Access Compliance Report Public Rights-of-Way (Pedestrian Signals)

Main Street: VALENCIA_AVE Cross Street: VALENCIA_AVE Location: NW

ADA ID: SGAT220218171446 Signal Type: One Push Button-Non APS Overall Compliance: No Severity Scores: BTN 1: 35 BTN 2: N/A No BTN: N/A

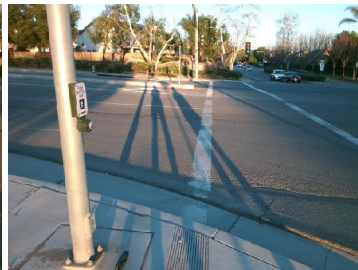
OC Std/PROW: R404.2, R403.4, MUTCD 4e.08

Possible Solutions: Replace Signal Push Button With APS Button. Remove and Replace Clear Space.
